## DFCM Addendum #1

**Reference:** Zions Building Kitchen Update  
Utah State Fairpark  
DFCM Project #25266370  
U3P Event #DA25040

# ADDENDUM NO. 1

## FAIRPARK ZION'S KITCHEN

EP101

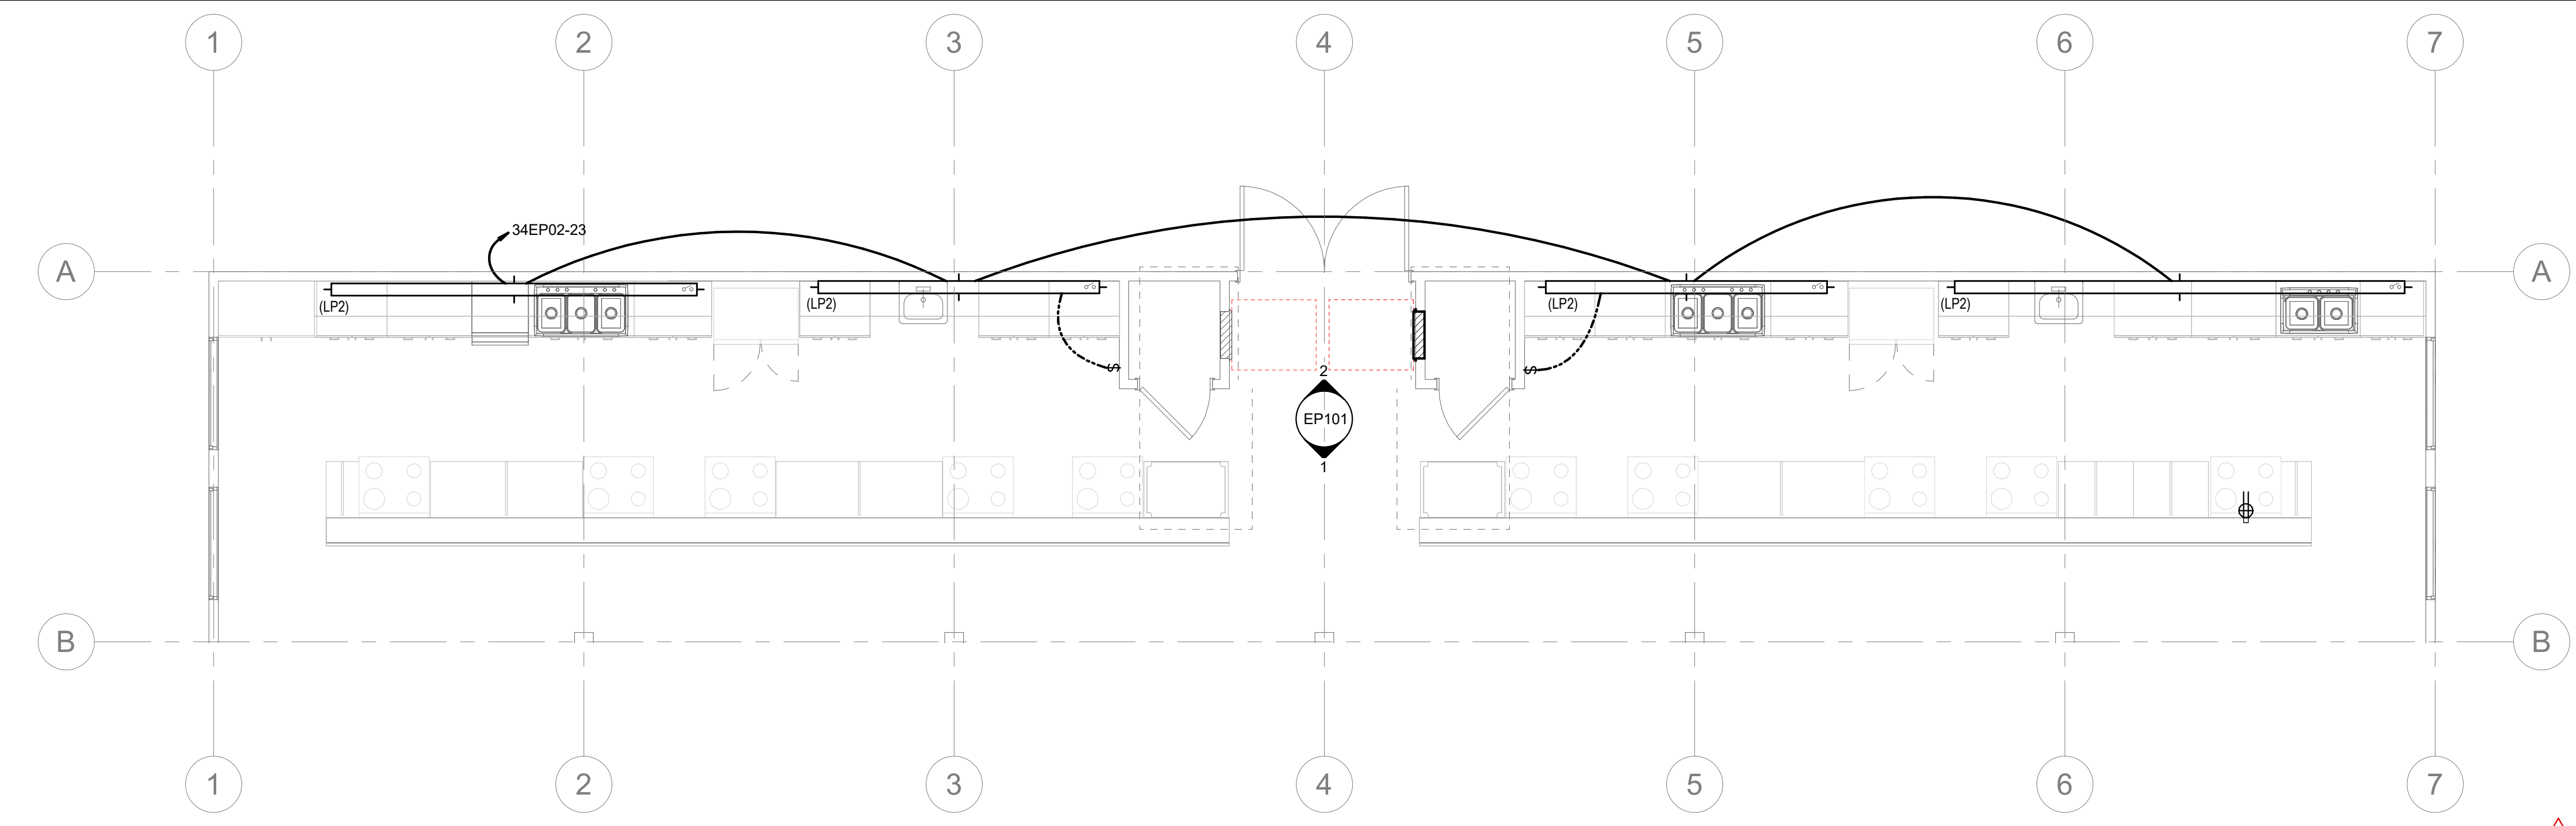
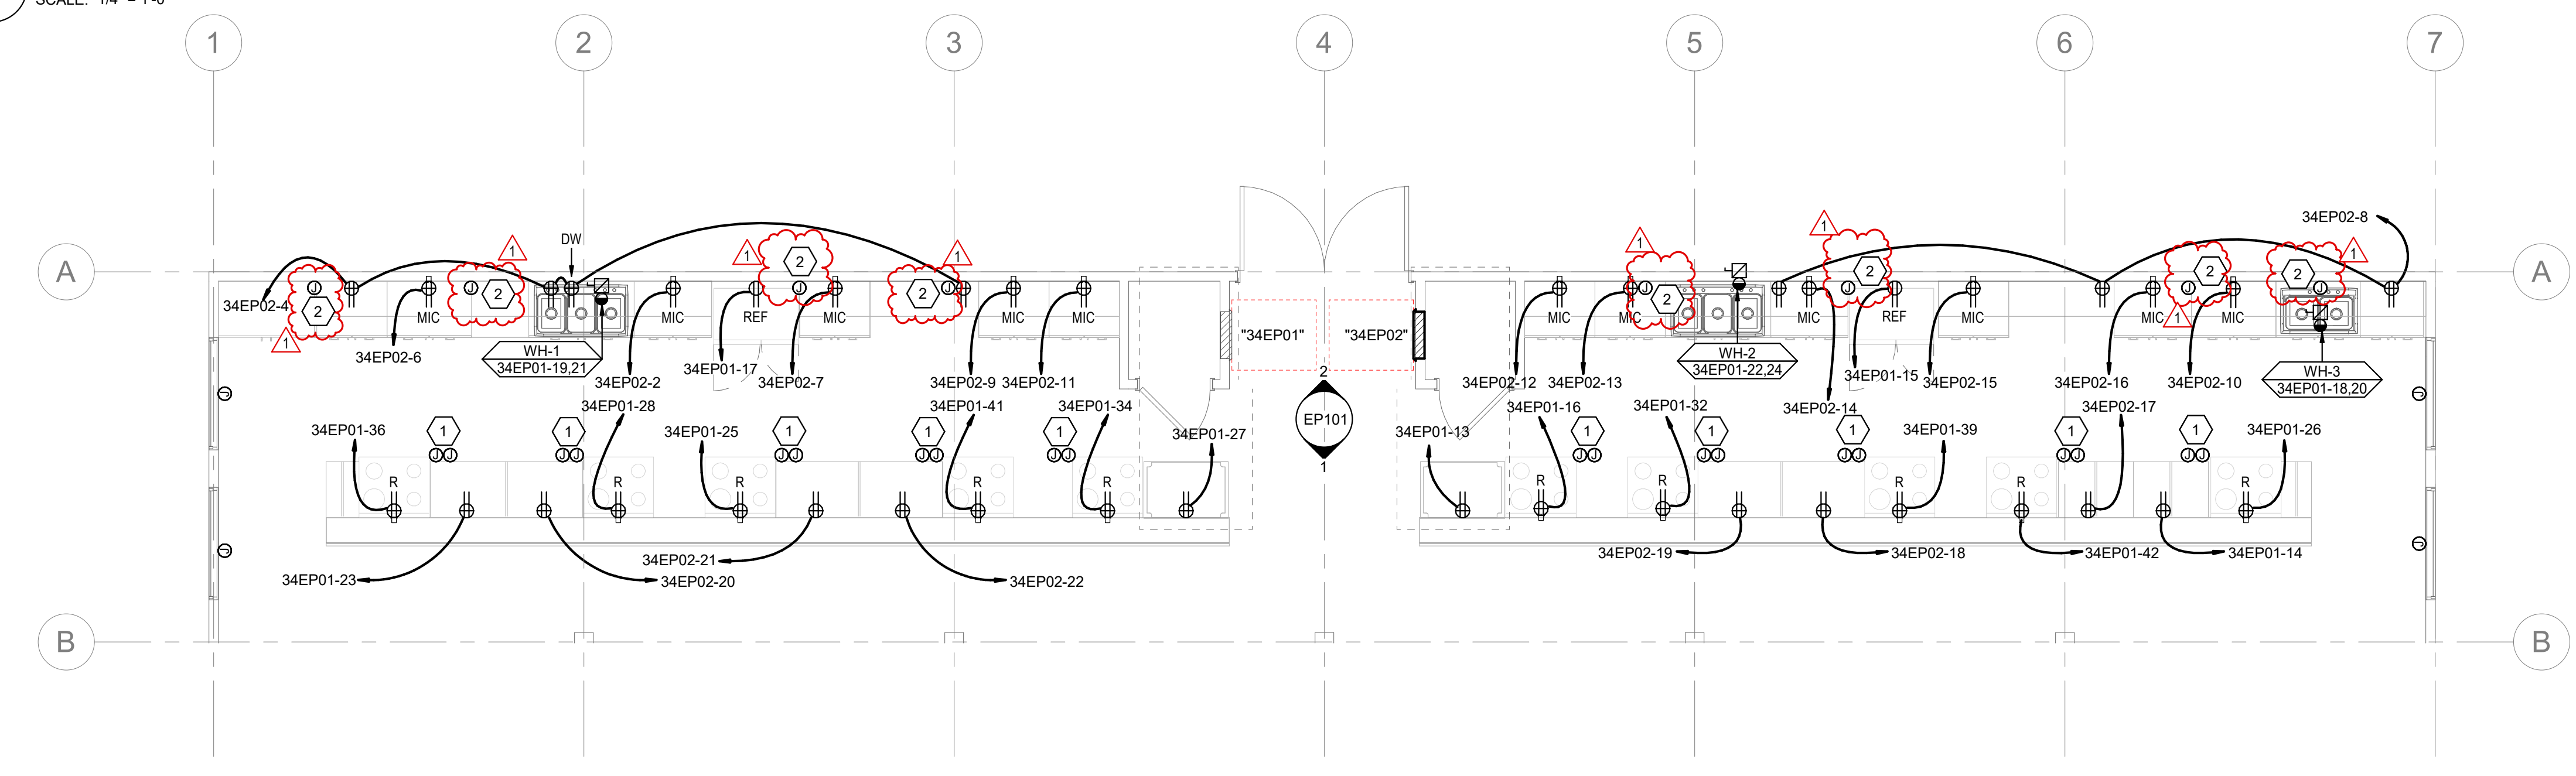
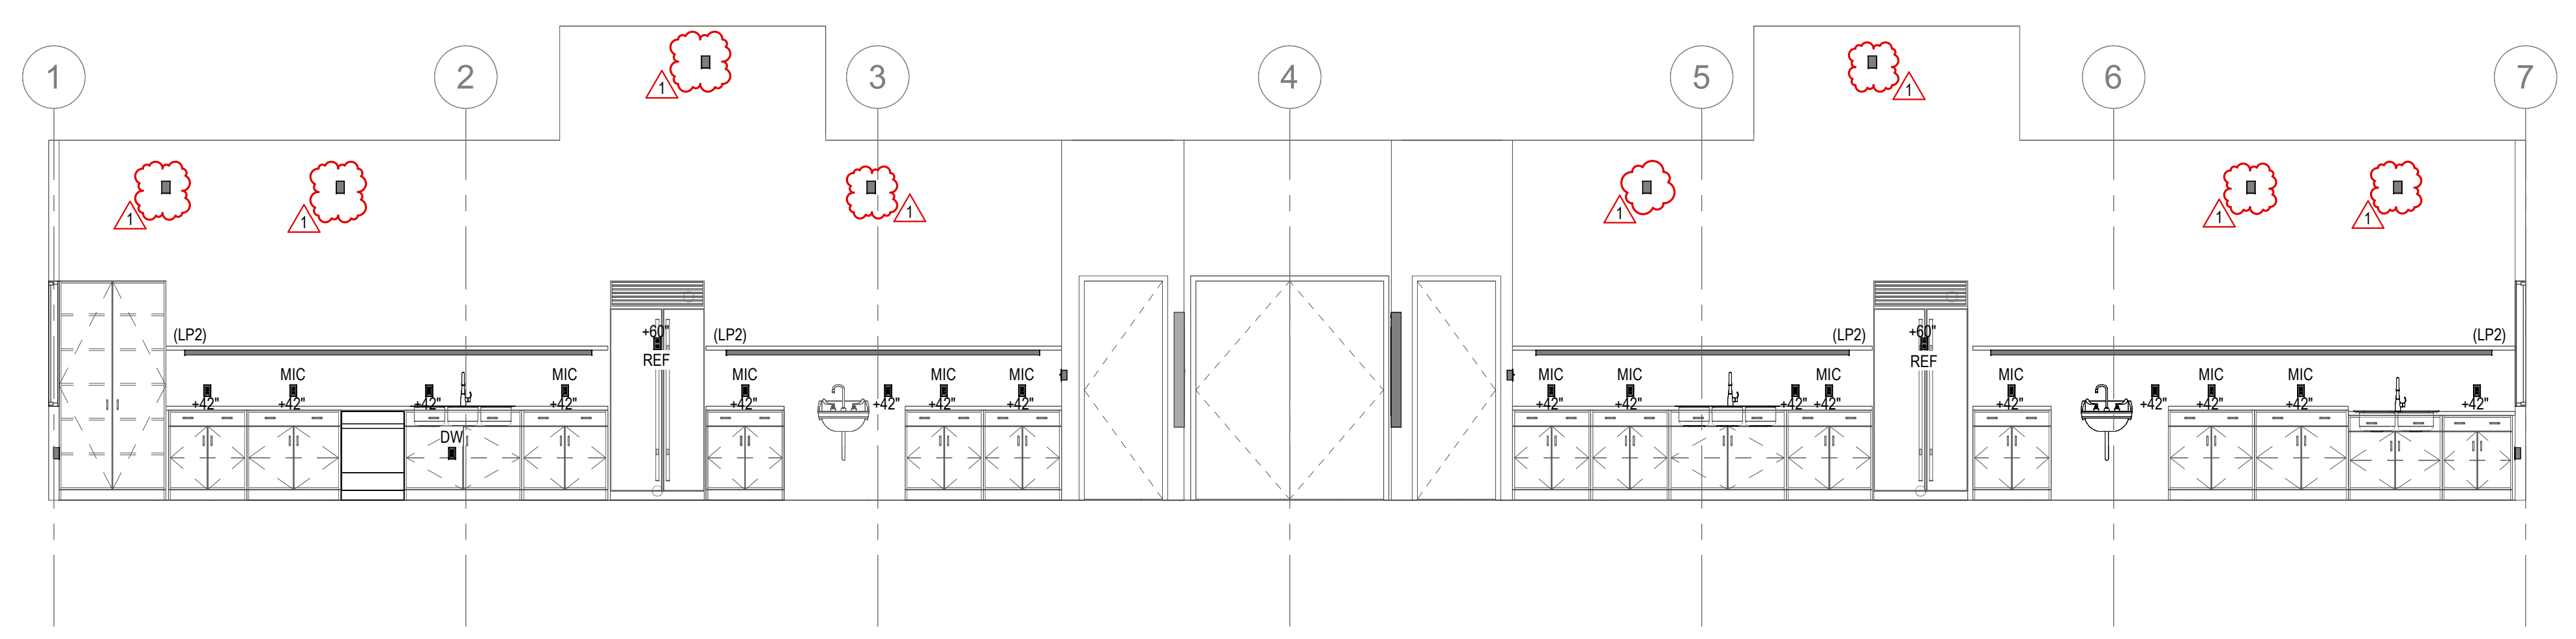
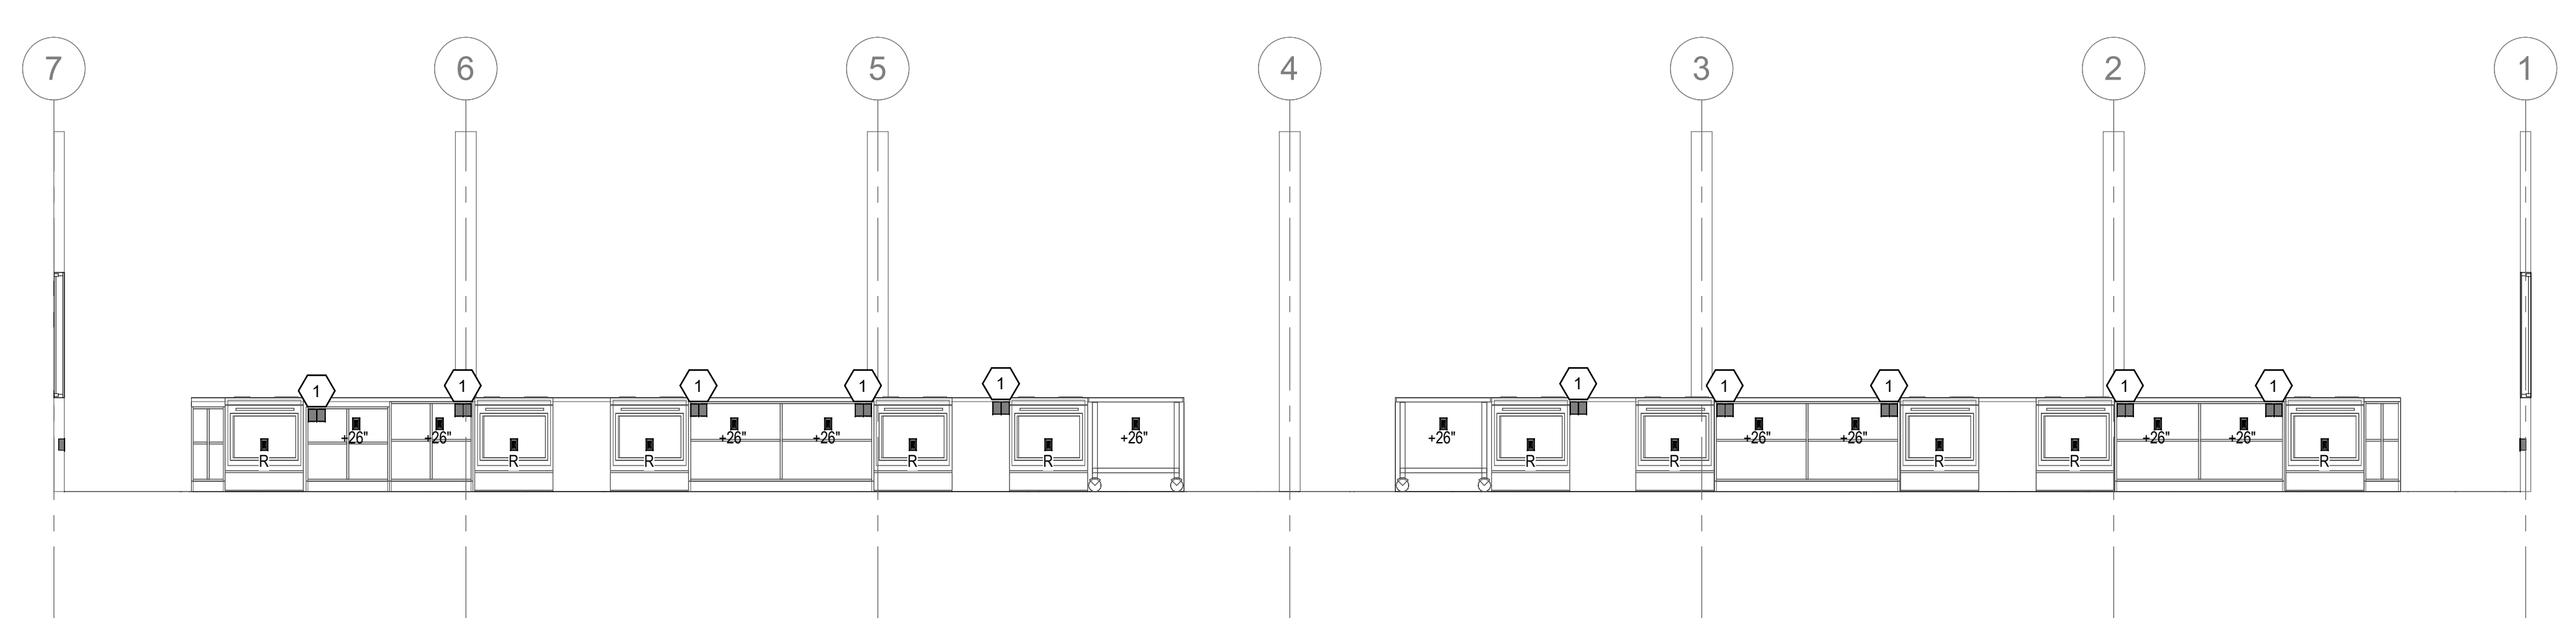
1. **EP100** – Added Electrical motor shade controls to the north windows.
2. **EP101** – Added electrical motorized shade controls to elevation view. Added keynote 2.
3. **EP601** – Updated Electrical fixture schedule. Updated panel schedule '34EP02'to include new circuits.

- PROVIDE REMOTE GFCI TEST SWITCHES FOR BOTH THE UNDER COUNTER OUTLET AND THE OVEN OUTLET CIRCUITS. COORDINATE WITH MILLWORK PROVIDER AND ARCHITECT FOR EXACT MOUNTING LOCATION.
- PROVIDE ALL ELECTRICAL CONNECTIONS TO MOTORIZED SHADES. PROVIDE ALL ROUGH-IN, CABLING, AND TERMINATIONS FOR ALL CONTROLS PER MANUFACTURERS SPECIFICATIONS.
